METROPOLITAN GOVERNMENT OF NASHVILLE AND DAVIDSON COUNTY

STAFF RECOMMENDATION 2812 Oakland Avenue January 18, 2012

Application: New Construction--addition
District: Belmont-Hillsboro Neighborhood Conservation Zoning Overlay
Council District: 18
Map and Parcel Number: 11704025700
Applicant: Michael Ward, architect
Project Lead: Melissa Baldock, melissa.baldock@nashville.gov

2812 Oakland Avenue, front façade with enclosed front porch.

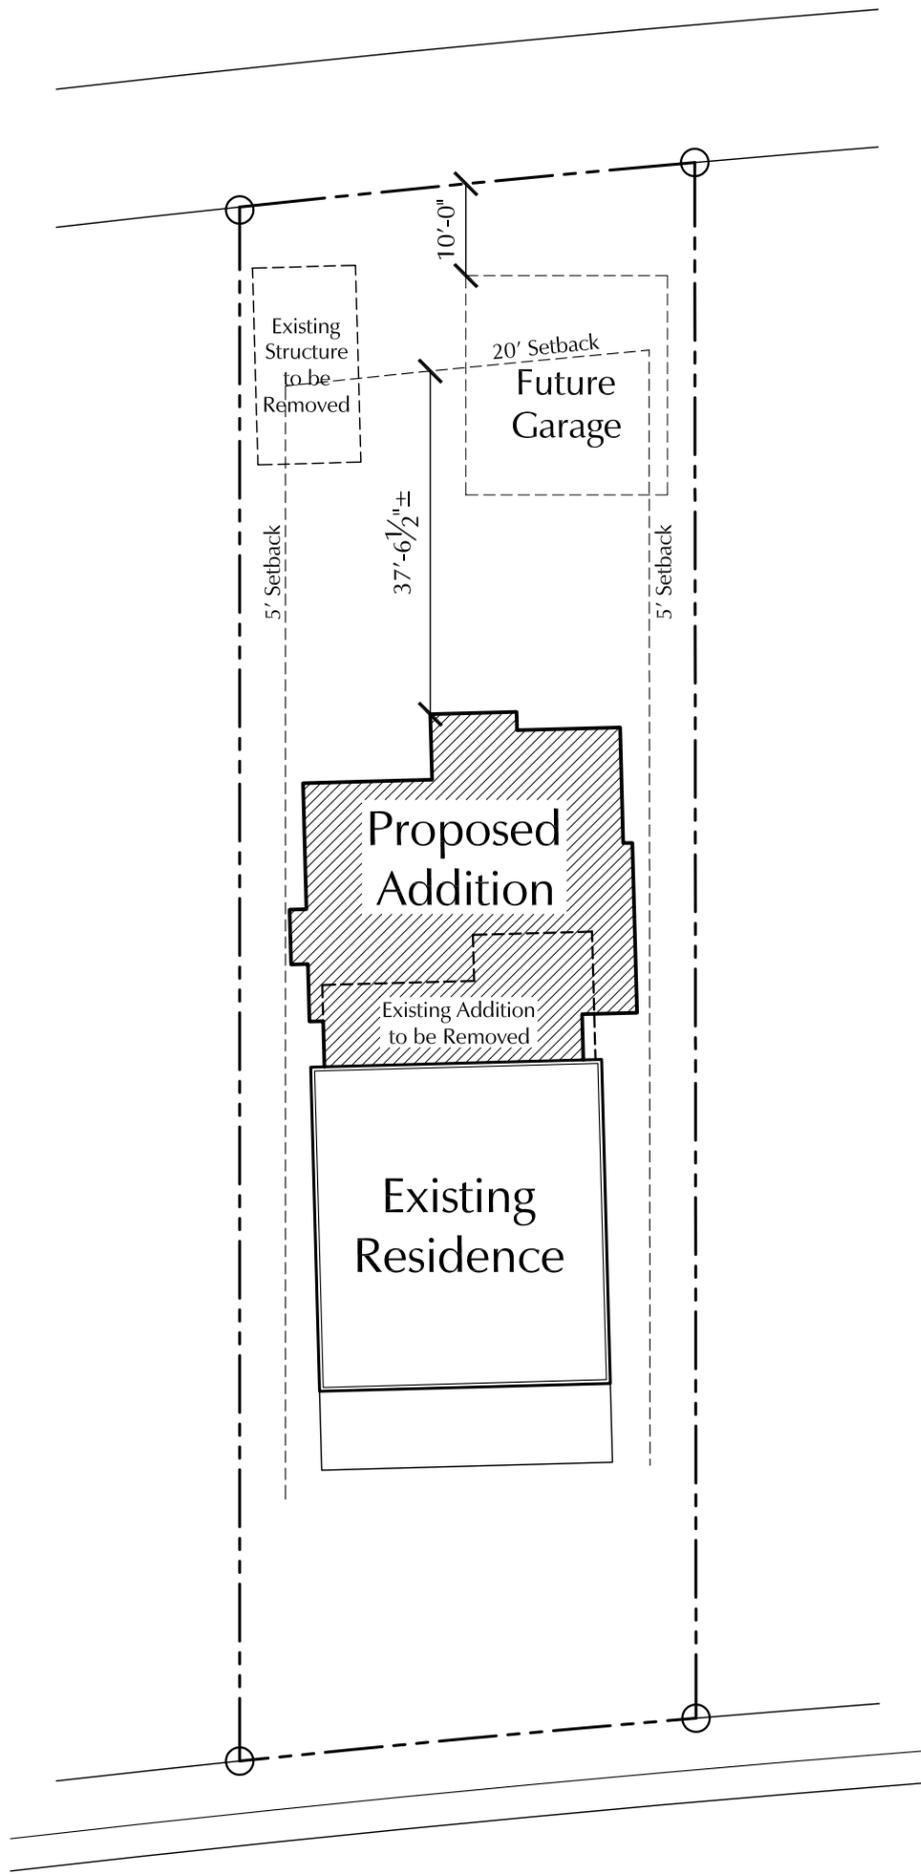
Front Porch and Dormer Restoration: The historic house's front porch has been enclosed. As part of the project, the application will be re-opening the porch and redesigning the first floor's front façade. Staff finds the proposed front façade configuration to be appropriate. However, staff asks that a condition of approval be that the existing porch columns be kept, if they are structurally sound, and that if photographic or documentary evidence of what the front façade originally looked like is found, then the applicant restore the front façade to its original appearance.

1. The existing porch columns be kept, if they are structurally sound;
2. If photographic or documentary evidence of what the front façade originally looked like is found, then the applicant restore the front façade to its original appearance;
3. Staff review the exposed front façade, once the existing enclosure is removed, to determine if any original openings and/or materials should be preserved; and
4. Staff review and approve a stone sample, the asphalt shingle color, deck railing material, and the window and door specifications and material prior to purchase and installation.

Site Development Plan

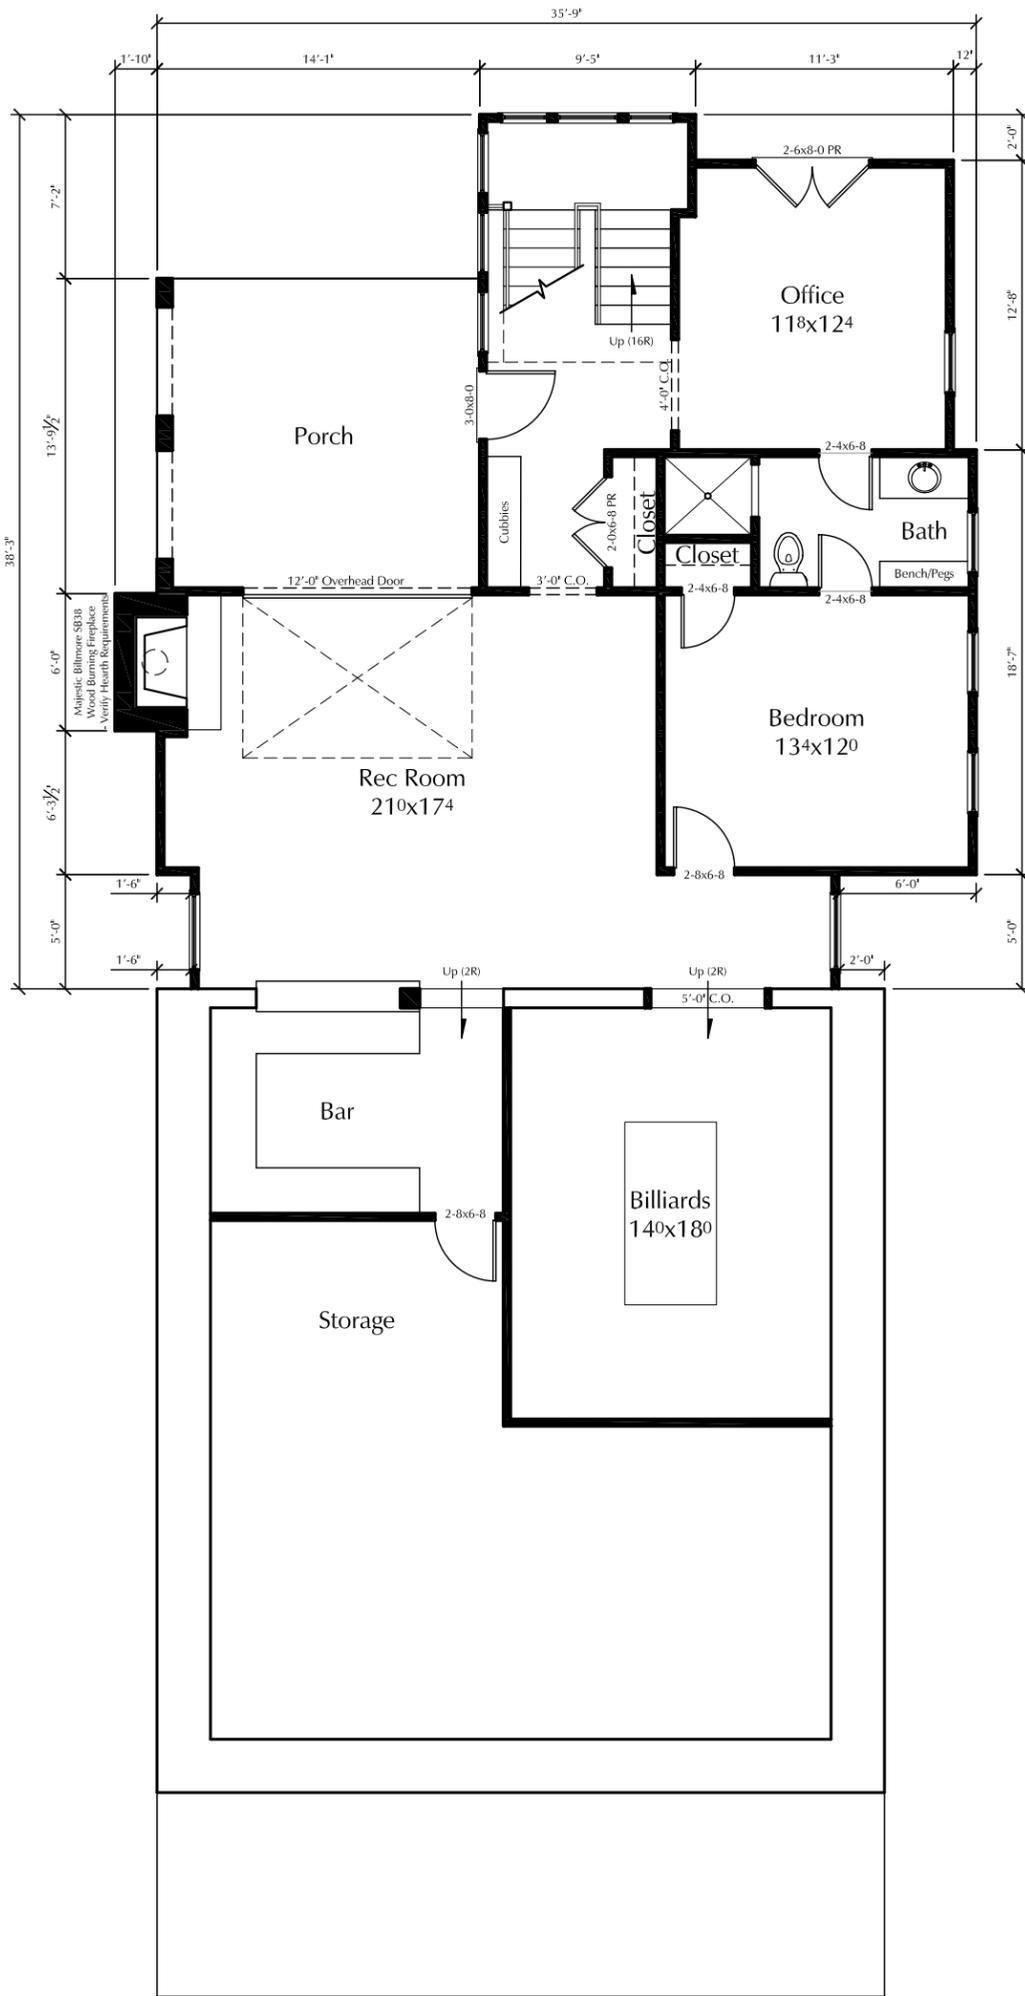
Location and Setback: The proposed addition is located in the rear of the property. It meets all of the base zoning requirements for setbacks. On the south/right side, it is a minimum of six feet (6') from the side property line and on the north/left side, it is a minimum of seven feet (7') from the side property line. (Note that the Codes Department does not consider chimneys when measuring setbacks.) The addition is over fifty-seven feet (57') from the rear property line.

Below is a chart outlining the percentage of open space for the site’s current conditions and the proposed conditions under the application, which include demolishing the existing accessory structure. Because the site plan indicates that a garage that is approximately twenty-feet by twenty-four feet (20’ X 24’)—or four hundred and eighty square feet (480 sq. ft) —may be constructed in the future, the percentage of open space for that potential future development has been included as well. However, because it is not currently part of the application and the size may change, staff will not address whether or not the potential future garage meets the guidelines for size, scale, and percentage of open space.

Front Elevation

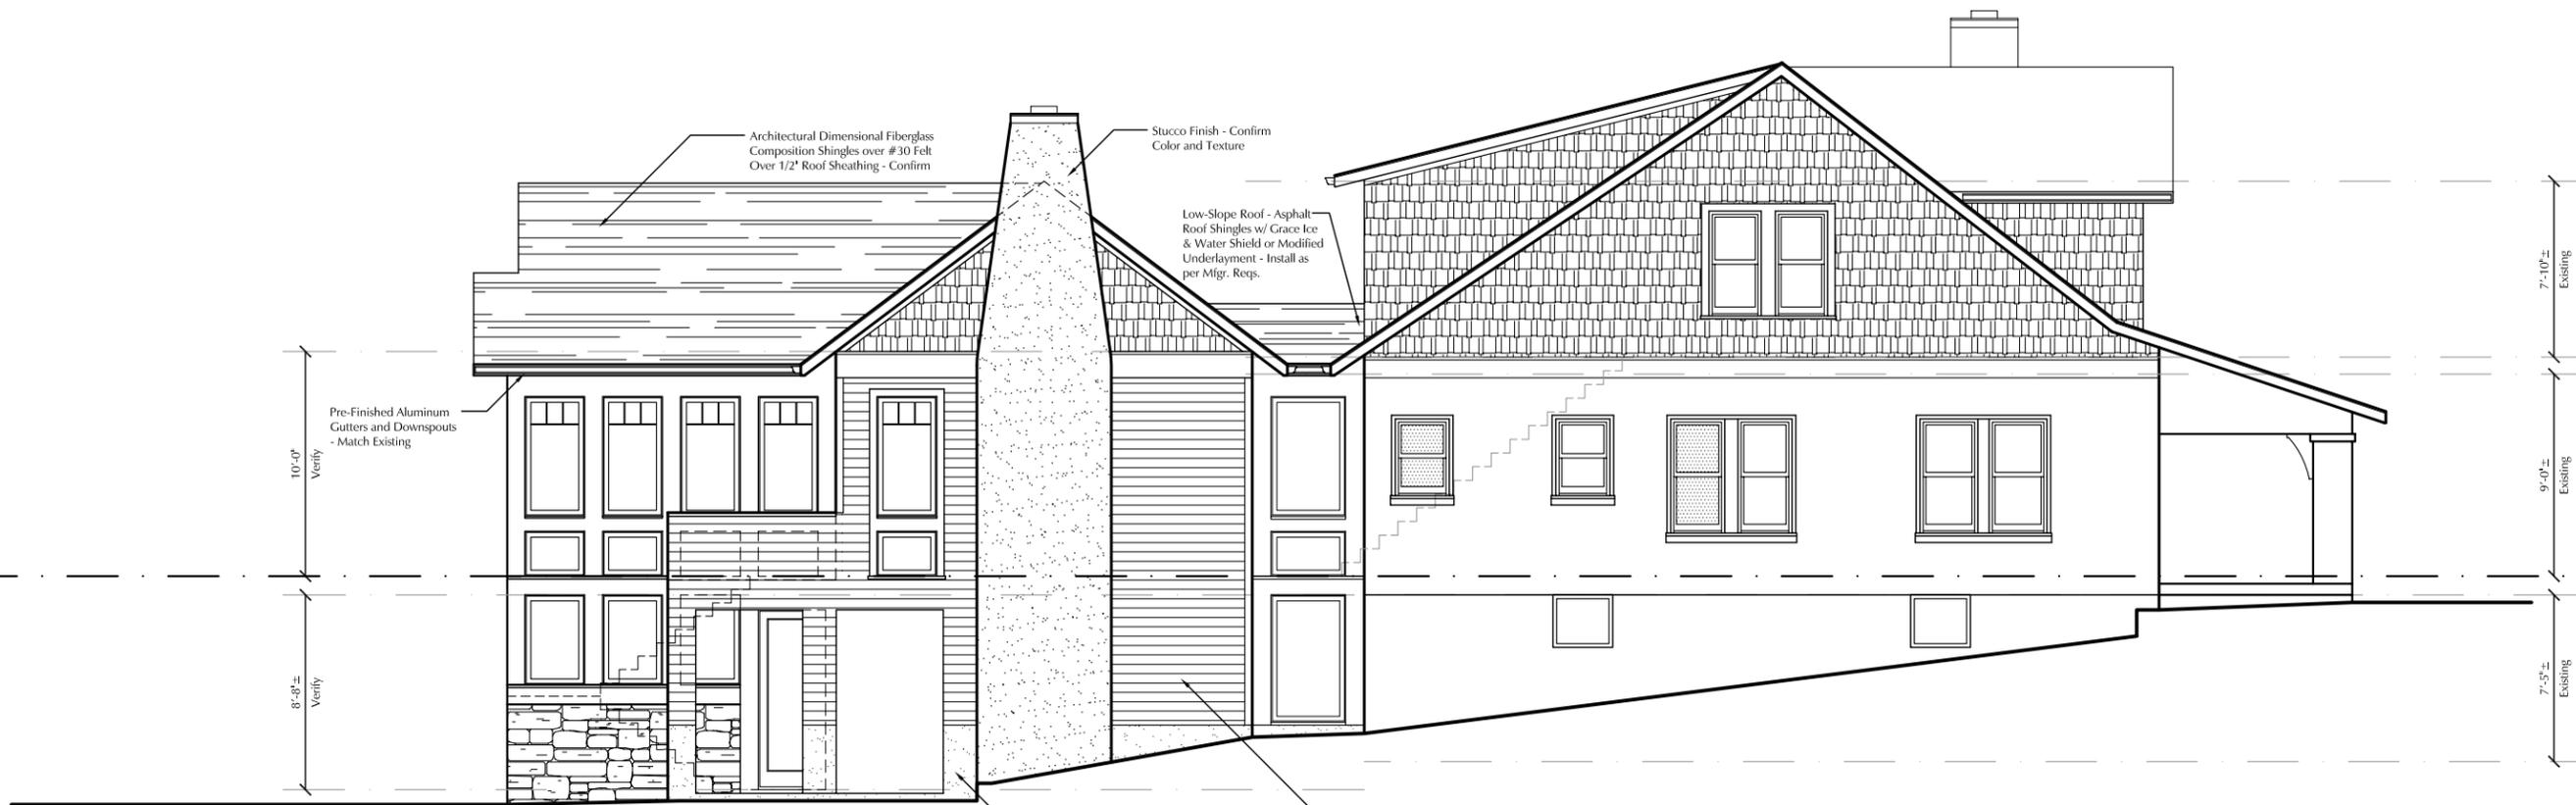
On the north/left side, the addition insets one foot, six inches (1'6") from the wall of the house for a length of five feet (5'), at which point the addition expands out to match the wall line of the existing house. Although there is a chimney that extends one foot, ten inches (1'10") beyond the wall of the house, MHZC staff, as well as the Codes Department, does not consider chimneys to be part of the building footprint. Staff finds the one foot, six inch by five foot (1'6" X 5') alcove on the north/left elevation to be

On the north/left side, the addition will step in two feet (2') from the sidewall of the house for a length of five feet (5'), at which point the addition extends out six feet (6'), meaning it extends four feet (4') beyond the sidewall of the house. Staff finds this to be appropriate because the house is shifted slightly to the north side of the lot so that at this location, the house is approximately ten feet (10') from the south/right side property line and seven feet (7') from the north/left property line. In addition, the structural alcove is inset sufficiently on this side to lessen the impact of the wider portion of the addition and it pushes the wider portion of the addition more than five feet (5') behind the back of the house and the drop in grade will also lessen the visual impact of the addition. Finally, the wider portion of the addition is appropriate because it will have a side-gabled roof form and will be a minimum of five feet (5') shorter than the historic house, lessening its impact on the historic structure.
